Site-Specific Sampling and Analysis Plan

**Investigation of Coal Yards in the Areas of Ash Pit Nos. 1 & 3
and Powerhouse No. 2 Ash Pit
Former Plum Brook Ordnance Works, Sandusky, Ohio**

Response to Review Comments
Draft Site-Specific Sampling and Analysis Plan
Investigation of Coal Yards in the Areas of Ash Pit Nos. 1 & 3 and
Powerhouse No. 2 Ash Pit
Former Plum Brook Ordnance Works, Sandusky, Ohio

FIGURE 1-3
 DETECTED CONSTITUENTS AT
 ASH PIT 1 IN OVERBURDEN/SHALE
 GROUNDWATER SAMPLES ABOVE
 RBSCs AND/OR BSCs (DECEMBER
 2008, MAY, AND NOVEMBER 2009)

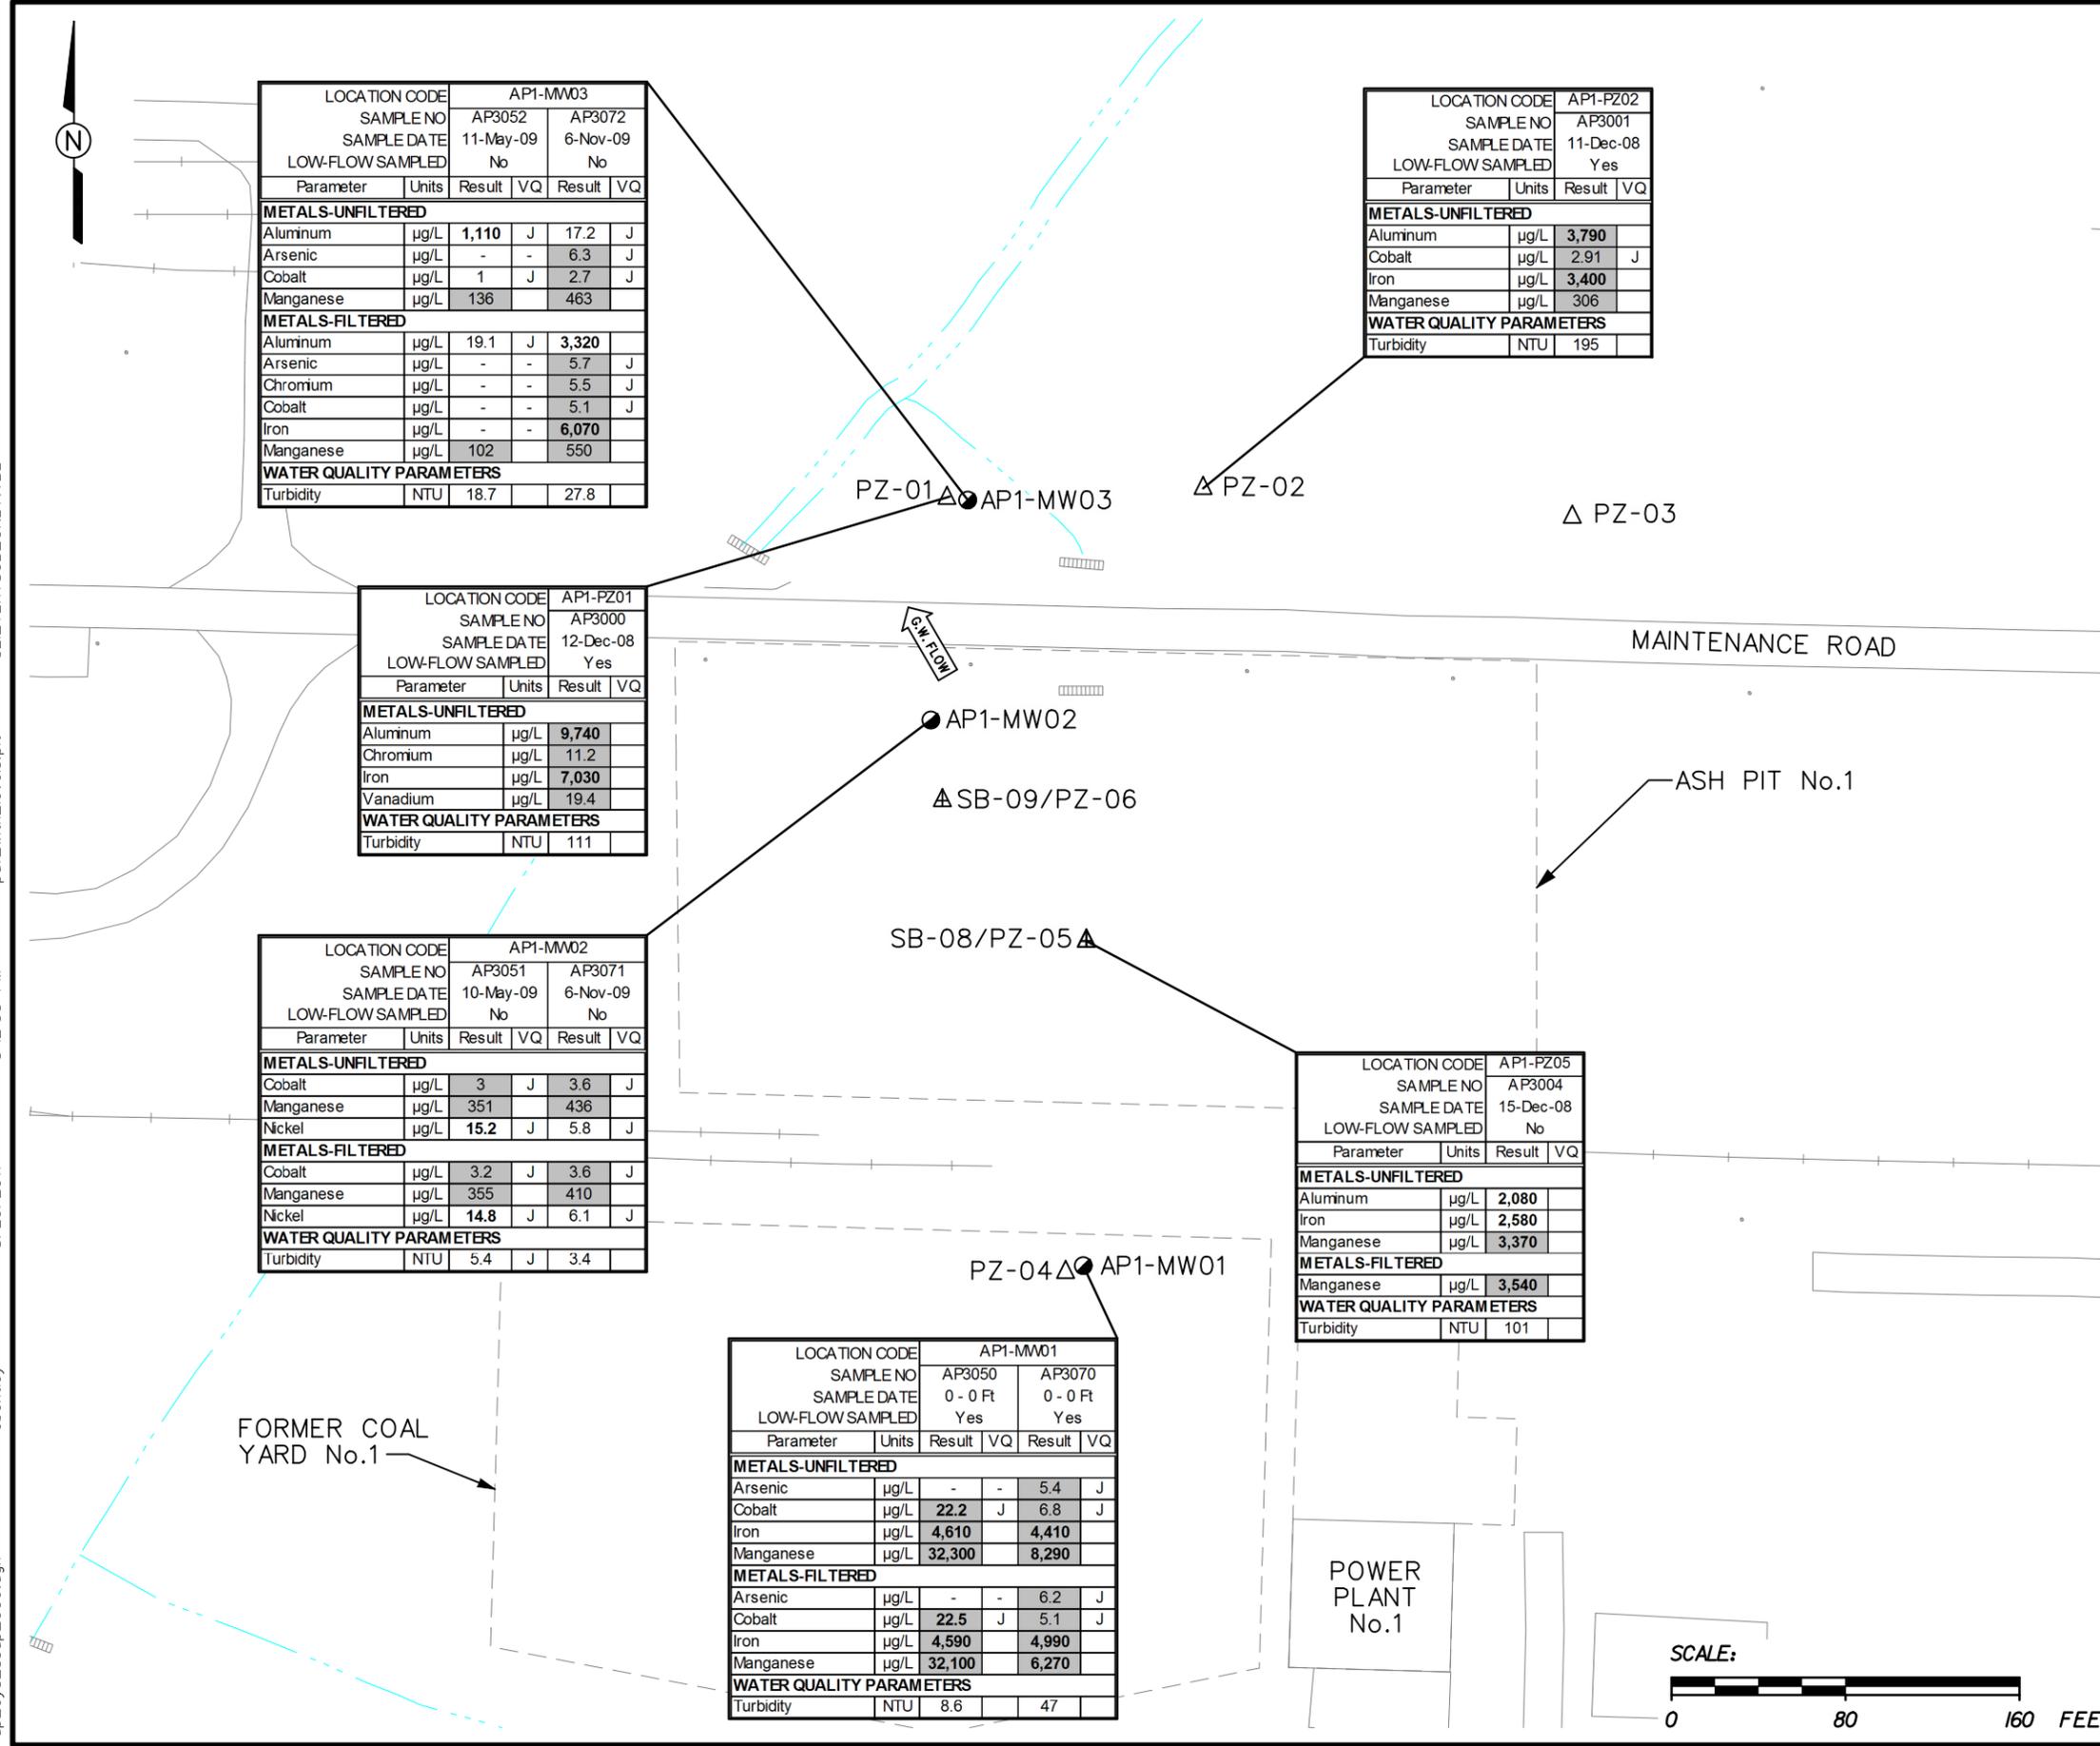
Comment 1: Page 1-2, Section 1-2, and Figure 1-3: As evidenced in Figure 1-3, a number of the wells with elevated manganese in the groundwater also have elevated iron. As iron and manganese both show the tendency to dissolve under reducing geochemical conditions, the coupling of elevated iron and manganese together may indicate (and be due to) reducing geochemical conditions. Recommend that the coupling of elevated iron and manganese, along with the potential that the elevated concentrations may be due, at least in part, to reducing geochemical conditions, be included in the discussion in Summary of Existing Data, Section 1.2.

Response 1: Review of the site specific overburden/shale groundwater data for Ash Pit 1 presented in the Final Ash Pit 1 and Ash Pit 3 Site Characterization Report (Shaw, 2010) indicates possible correlations between some of the groundwater geochemical parameters and dissolved iron and manganese concentrations. Groundwater quality data suggests that the overburden/shale may be characterized as being in a reduced state with relatively low dissolved oxygen concentrations (less than 3 mg/l) and negative oxidation/reduction potentials. Ferrous iron was only detected in one overburden/shale monitoring well (AP-MW01 at 2 mg/l and 4 mg/l). The text has been revised to incorporate additional information (DO, Eh, pH, ferrous iron, etc) from previous groundwater sampling events at Ash Pit No. 1.
